Planning & Development Consultants

RESPONSE TO THE SUBMISSION OF SIGNIFICANT FURTHER INFORMATION AS PART OF AN EXISTING THIRD PARTY PLANNING OBJECTION IN RESPECT OF A PLANNING APPLICATION IN THE AREA OF DUBLIN CITY COUNCIL, REG. REF. 2683/21. THE DEVELOPMENT CONSISTS OF THE CO PERMISSION FOR DEVELOPMENT AT A SITE (C.039HA) AT GLENAVON HOUSE, 46 BALLYMUN ROAD, GLASNEVIN, DUBLIN 9. THE SUBJECT SITE IS GENERALLY BOUNDED TO THE WEST BY BALLYMUN ROAD AND CLONMORE COURT APARTMENTS, TO THE NORTH BY GLENAVON COURT AND HILLCREST COURT APARTMENTS, TO THE EAST BY THE REAR GARDENS OF HOUSES ON ST. MOBHI ROAD, AND TO THE SOUTH BY MOBHI COURT APARTMENTS AND HOUSES AT THE HAVEN. THE DEVELOPMENT WILL CONSIST OF THE CONSTRUCTION OF A 5 TO 6 STOREY APARTMENT BUILDING (TOTAL GFA C.5,330 SQM EXCLUDING CAR PARK), PARTIALLY OVER BASEMENT, ACCOMMODATING 52 NO. RESIDENTIAL UNITS (13 NO. 1-BED APARTMENTS, 9 NO. 2-BED APARTMENTS, 17 NO. 2-BED DUPLEX APARTMENTS, 8 NO. 3-BED APARTMENTS AND 5 NO. 3-BED DUPLEX APARTMENTS), ALL WITH PRIVATE BALCONIES ON THE EAST OR WEST ELEVATION (ETC). 1 NO. CAR SHARE SPACE AT SURFACE LEVEL. 37 NO. CAR PARKING SPACES AT BASEMENT. 80 NO. BICYCLE PARKING SPACES. ESB SUBSTATION A

Fig. 38: Recommended storeys to be removed & remaining top storey re-designed to remove overlooking

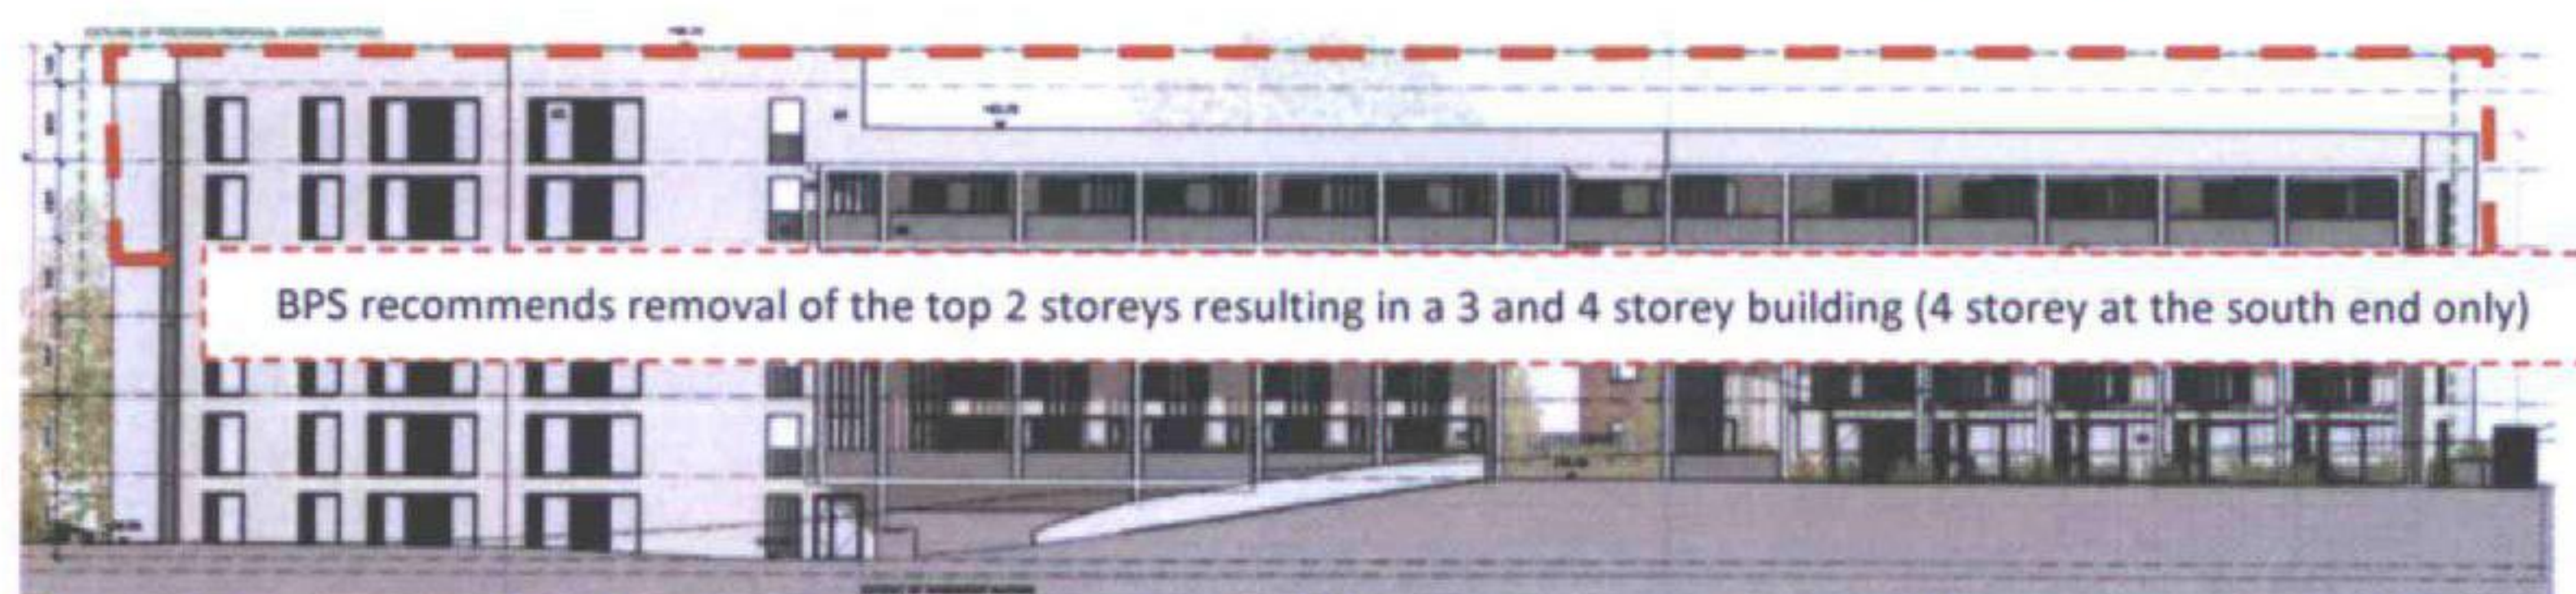
- **In respect of the height, scale, length, and massing of the scheme:** The quantum of development shoe-horned into the Applicant site is excessive. As submitted, the scheme would appear substantially over-developed in this site. The scheme needs to be reduced in height, scale, length, and massing. The maximum heights on this site should be 3 and 4 storeys. The 4th storey should only be allowed at the south end where the Lower Ground Level is not visible from adjoining St. Mobhi Road rear gardens and, as such, the building is 3 and 5 storeys as seen from our clients' properties. The east elevation should be revised as shown in Fig. 38. **The scheme also needs to be broken up to address its monolithic single height roofline and bulky east elevation.**

- **Setbacks from boundaries:** The Applicant scheme's Blocks B and C need to be setback further from its eastern boundary shared with our clients' properties on St. Mobhi Road. As it stands, the scheme is setback from the western boundary in a manner that results in an imbalance of residential and visual impacts that is excessively negative regarding our clients' properties on St. Mobhi Road.

4) 00996886.pdf

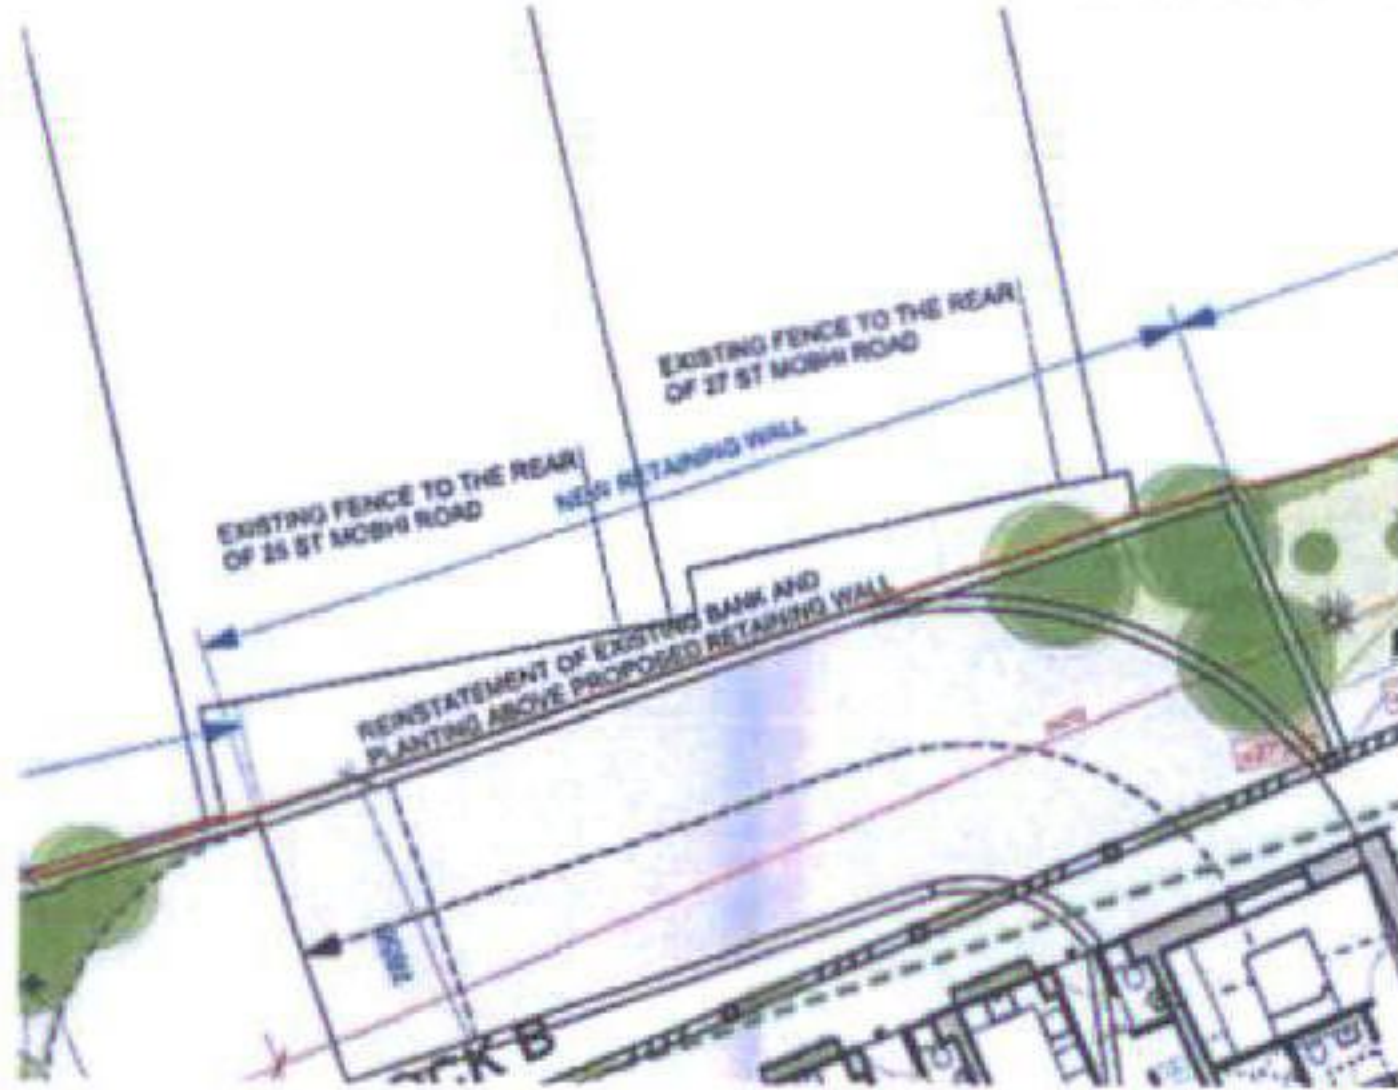
Reinstatement of existing bank & planting above proposed retaining wall refers to #25 land
This needs to be moved onto their property. How can planting above their wall be reinstated when it refers to #25 and #27's property?
